ADDENDUM NO. 4

TO: PLANS AND SPECIFICATIONS FOR STATE OF MISSOURI

Renovate Mechanical / Electrical / Life-Safety / State Office Building
Jefferson State Office Building
205 Jefferson Street
Jefferson City, MO 65101
PROJECT NO. O1911-01

1 FINISH PLAN - BASEMENT
 1/4" = 1'-0"

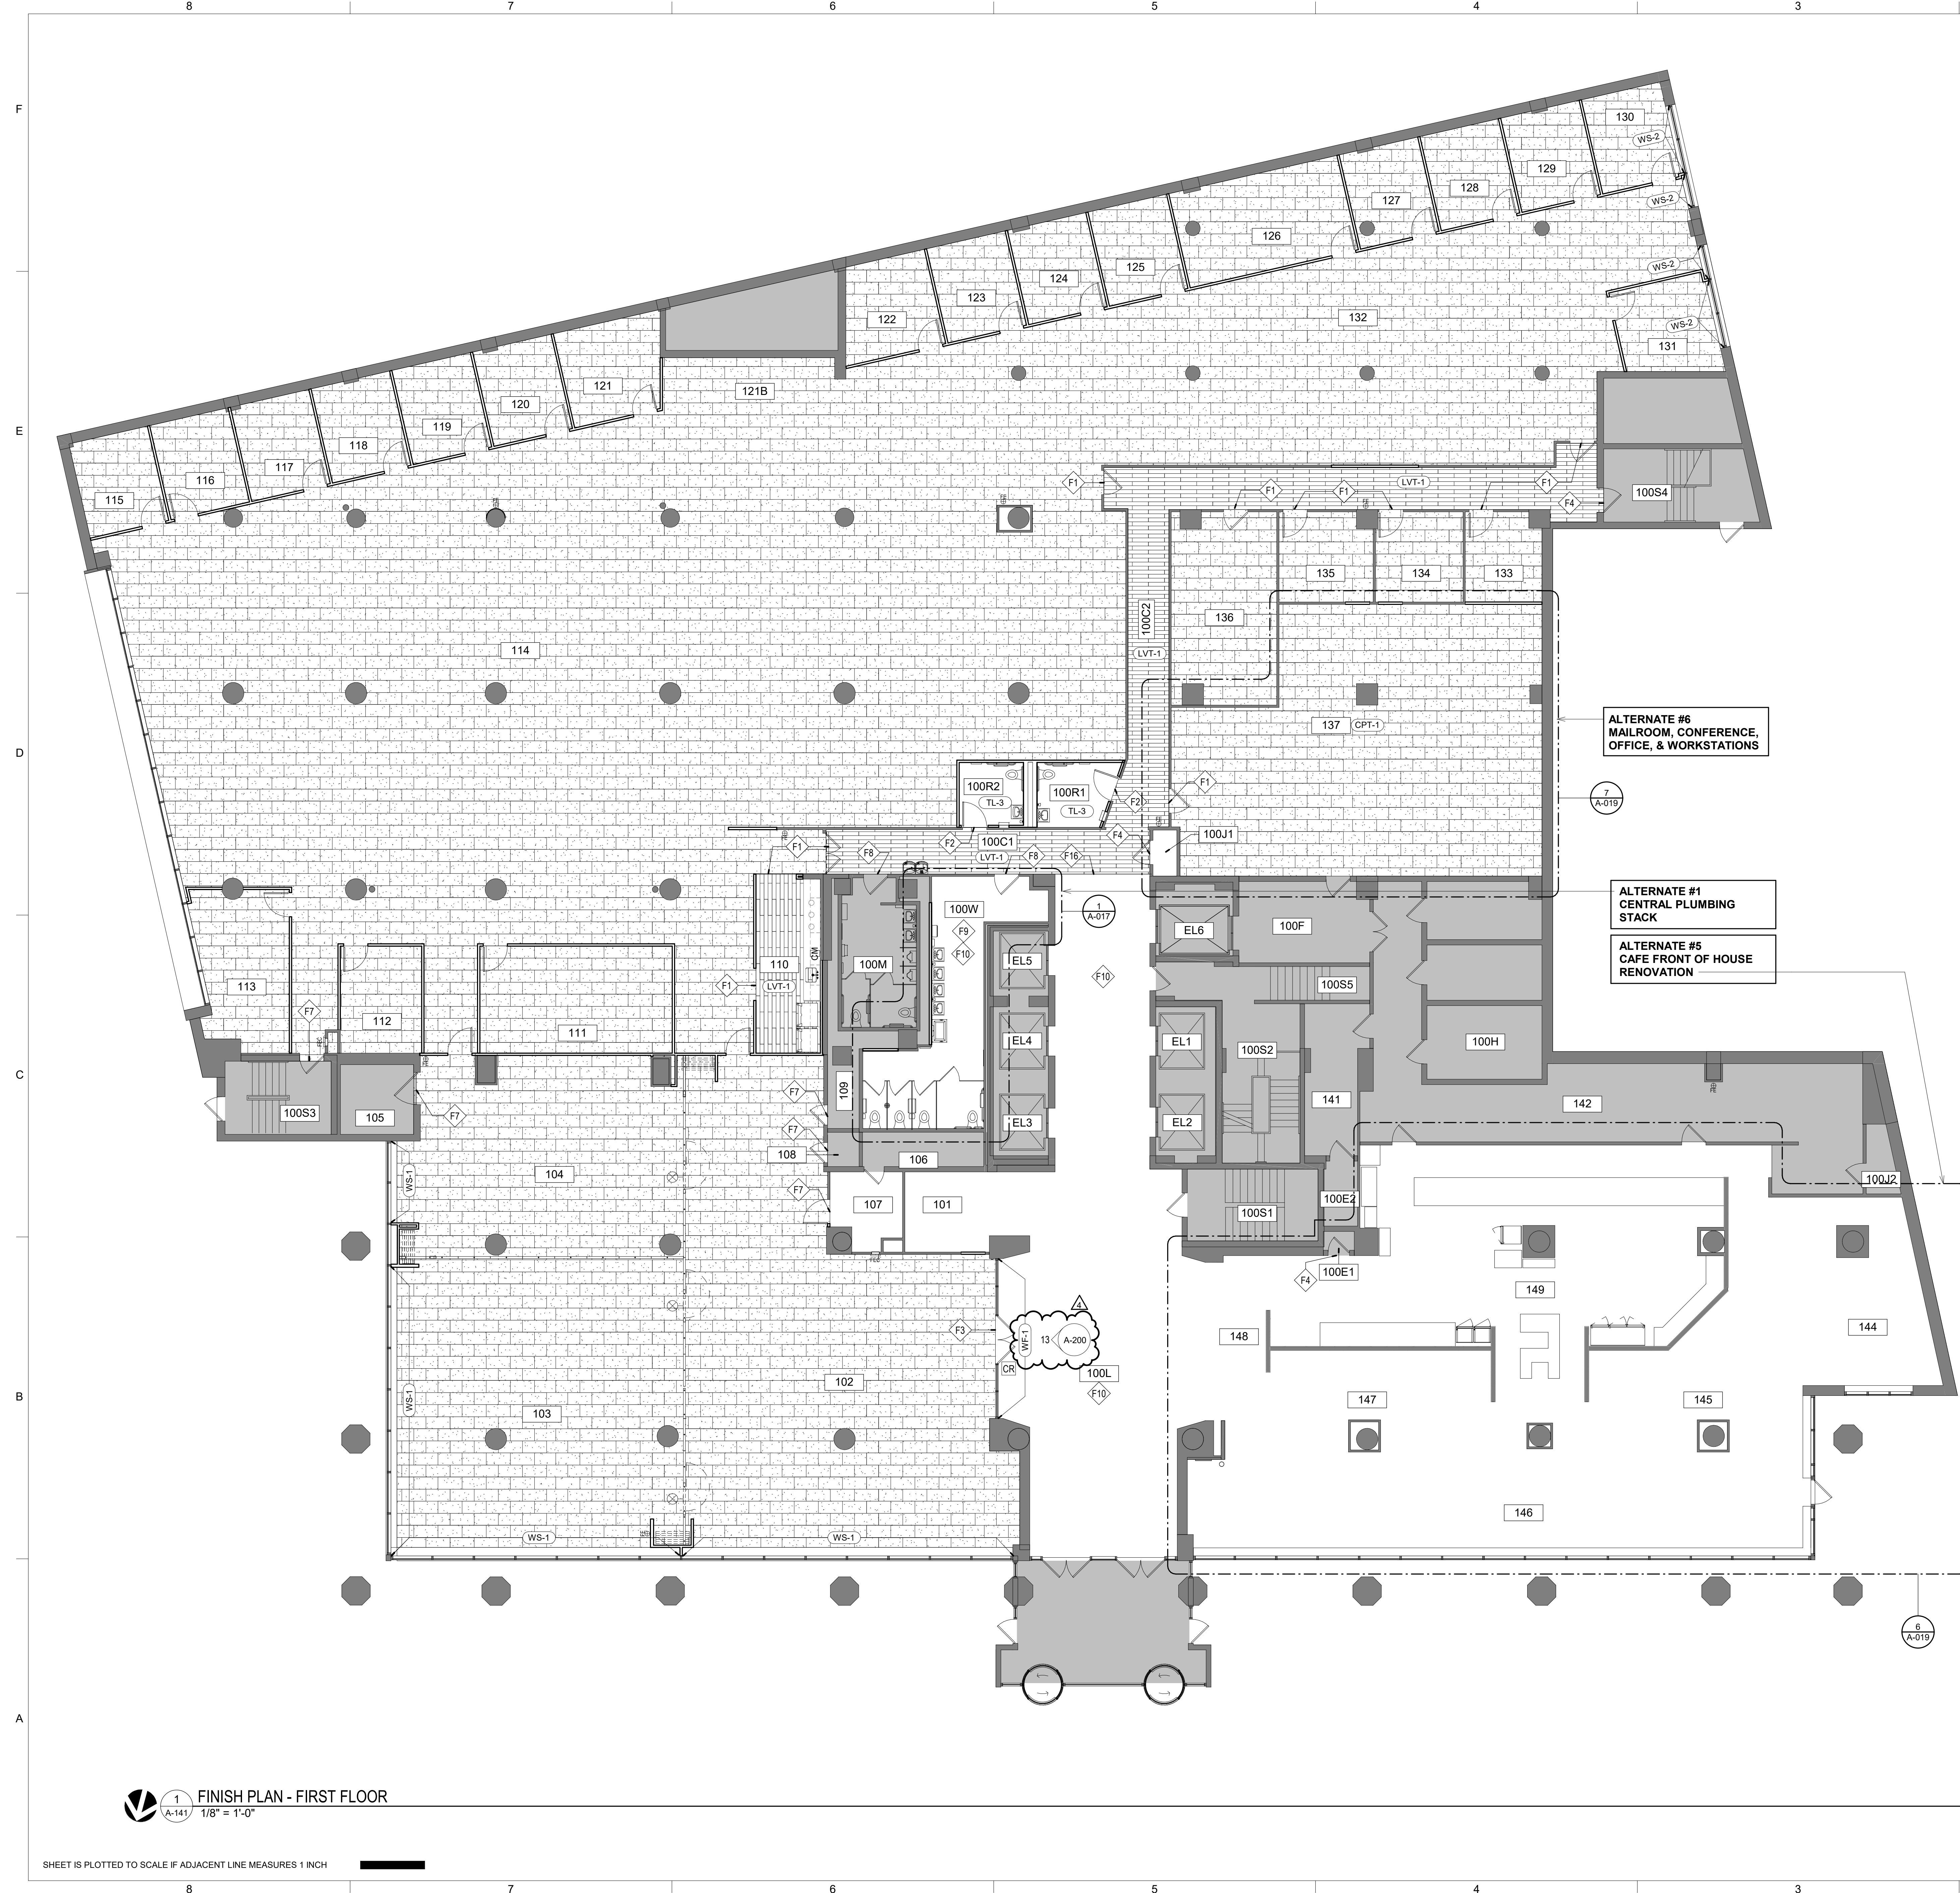
1. Drawing A-140:

- a. UPDATE – Finish Legend – Window Film – WF-1, revised finish information schedule per further discussion with the State.

1 FINISH PLAN - FIRST FLOOR
A-141 1/8" = 1'-0"

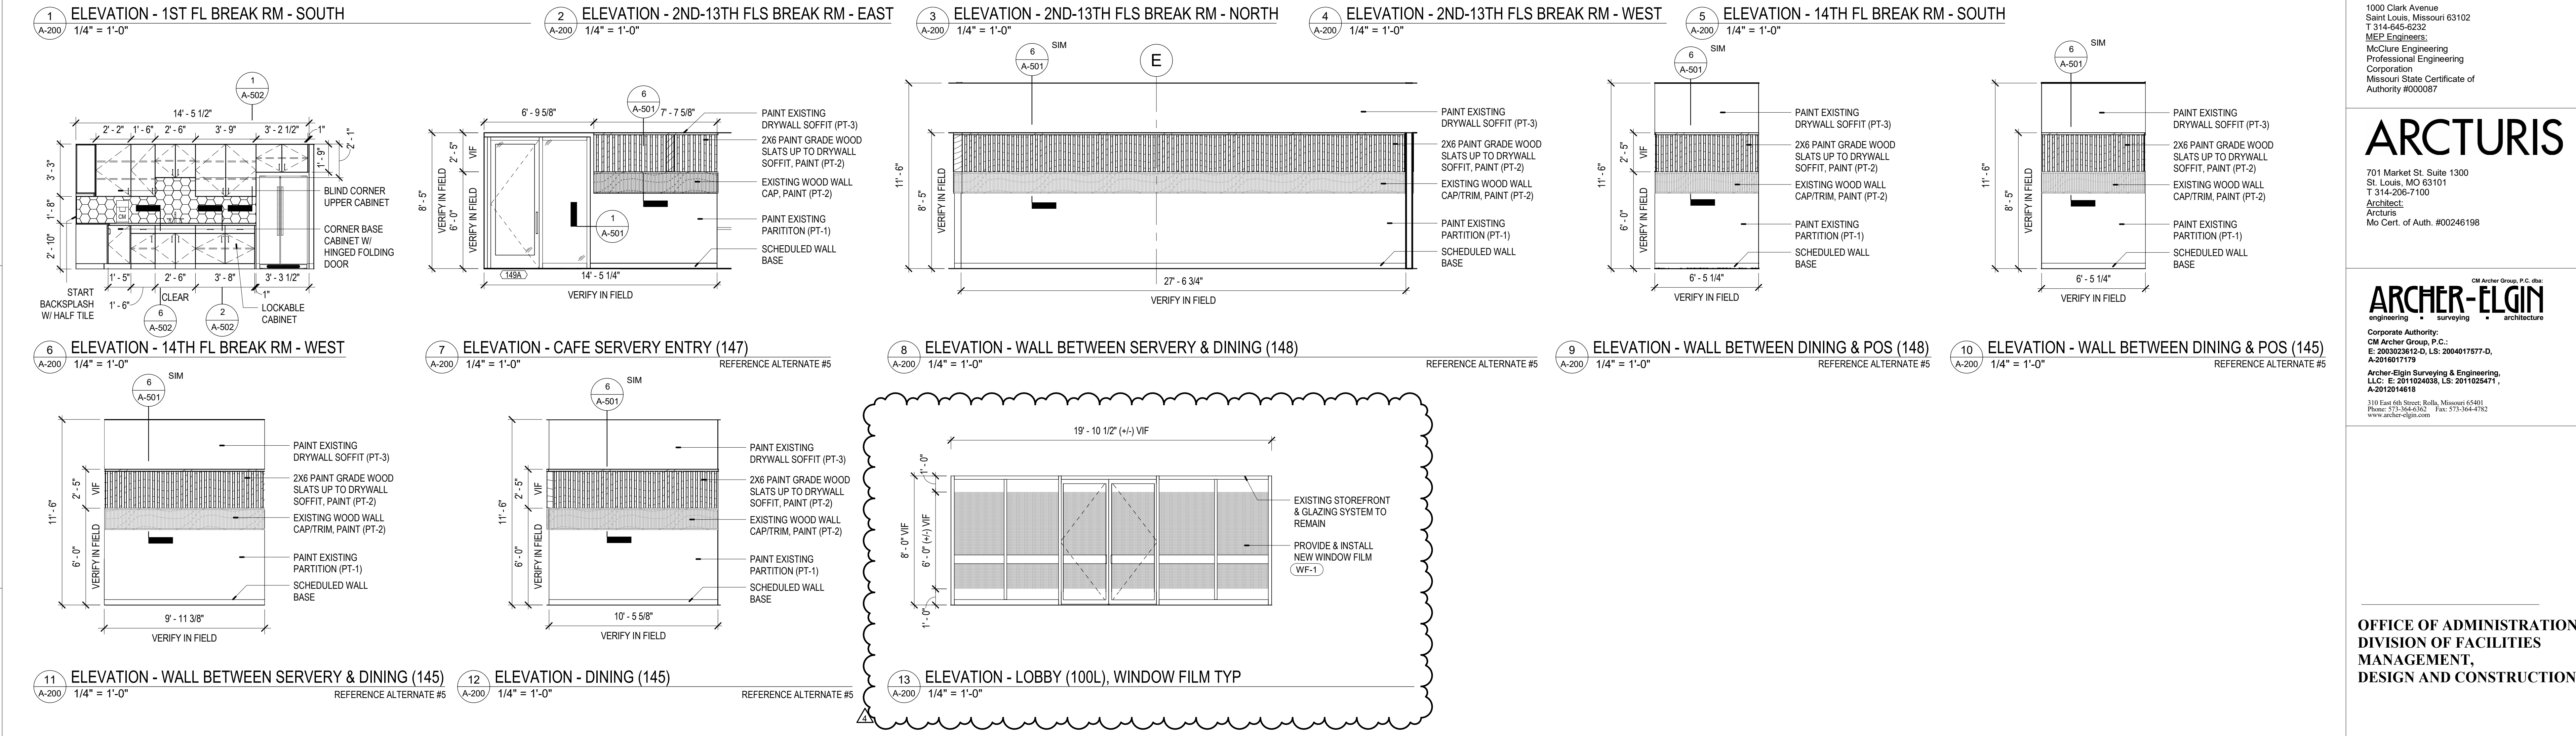
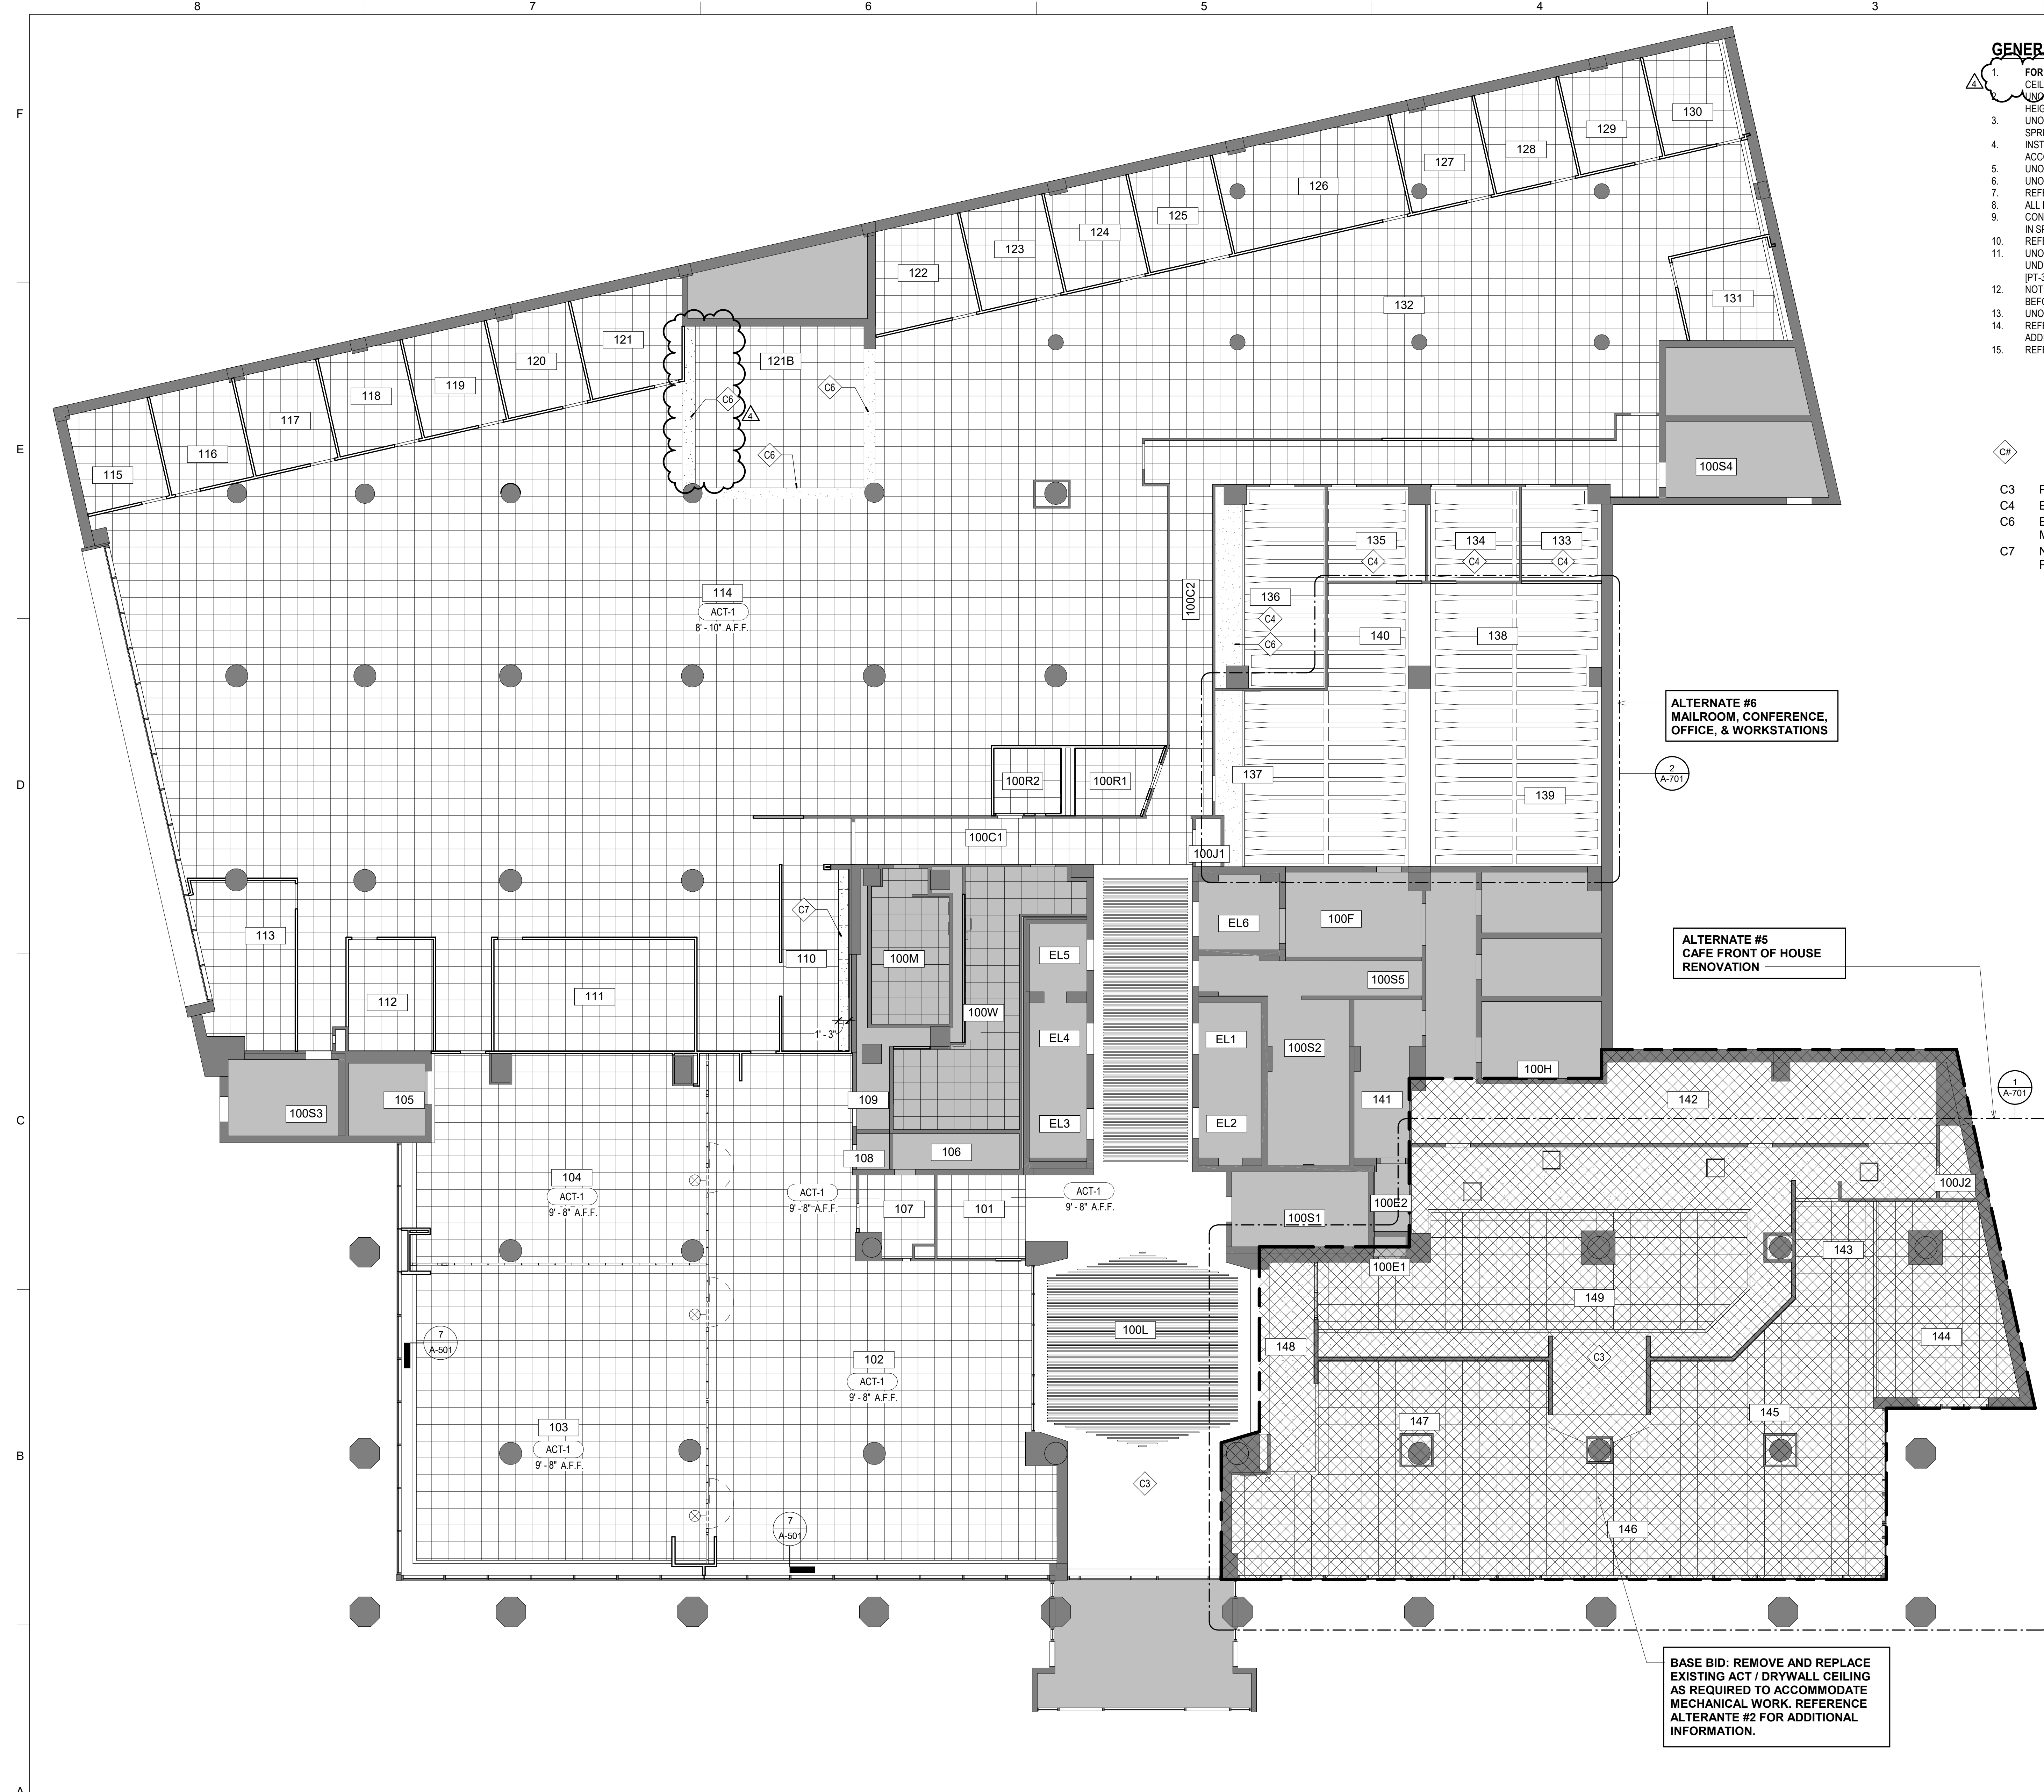
2. Drawing A-141:

- a. ADD – Finish Plan #1 – Existing glass wall and doors leading from room 102 to room 100L to receive window film (WF-1). Add finish elevation 13/A-200.
